Technical Service Bulletin: tsb080053	Released Date: 30-Jul-2008
Non-Matching Connecting Rod and Rod Cap Serial Numbers

Non-Matching Connecting Rod and Rod Cap Serial Numbers

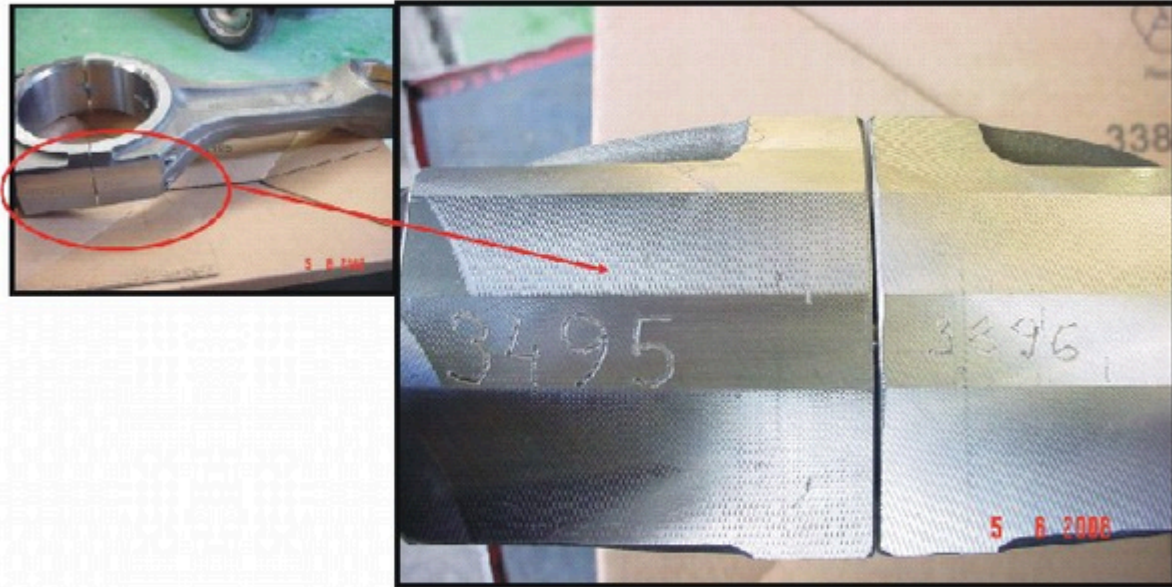
Non-matching connecting rod and connecting rod cap serial numbers have been found on new connecting rods being unpacked for assembly.

Connecting rod cap and connecting rod serial numbers should be identical. Connecting rod and connecting rod cap serial numbers can be found on the machined side of the big end of the connecting rod.

Any connecting rods found with non-matching serial numbers should **not** be used and returned to PDCs.
